Access Compliance Report Public Rights-of-Way (Curb Ramps)

Intersection ID: 31707 Main Street: ATLAS_CEDAR_DR Cross Street: WEEPING_FIG_LN Location: NE

ADA ID: CE8B053FBC5C Ramp Type: PerpDiag Initial Pass/Fail: Fail Overall Compliance: No Severity Score: 21.25

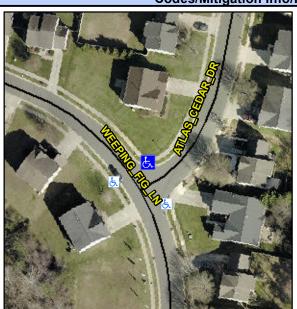
Not Found, R304.5.1, R304.2.2

Compliance Description Da		Data	Compliance Description		Data
N/A	Ramp Length (in)	47.0	No	Ramp Slope (%)	10.8
No	Ramp Width (in)	43.0	Yes	Ramp XSlope (%)	0.7
N/A	Flare Type LT	N/A	N/A	Flare Type RT	N/A
N/A	Flare Slope LT (%)	N/A	N/A	Flare Slope RT (%)	N/A
N/A	Flare Traversable LT?	N/A	N/A	Flare Traversable RT?	N/A
N/A	Landing Length (in)	N/A	N/A	DWS Provided?	N/A
N/A	Landing Width (in)	N/A	N/A	DWS Contrast?	N/A
N/A	Landing Slope (%)	N/A	N/A	DWS Length (in)	N/A
N/A	Landing X Slope (%)	N/A	N/A	DWS Full Width?	N/A
N/A	Landing Curb? (Y/N)	N/A	N/A	DWS Offset (in)	N/A
N/A	Shared Landing?	N/A			
N/A	Gutter Ponding?	N/A	N/A	Gutter Slope (%)	N/A
N/A	Gutter Lip Ht (in)	N/A	N/A	Gutter X Slope (%)	N/A
N/A	Painted X Walk1?	No	N/A	Painted X Walk2?	No
	X Walk 1 Direction	To W		X Walk 2 Direction	To S
N/A	X Walk 1 Width (in)	N/A	N/A	X Walk 2 Width (in)	N/A
	X Walk 1 Slope (%)	0.1		X Walk 2 Slope (%)	0.6
	X Walk 1 X Slope (%)	1.3		X Walk 2 X Slope (%)	2.0

Remove & Replace Curb Ramp With Two New Directional Ramps or Equivalent.
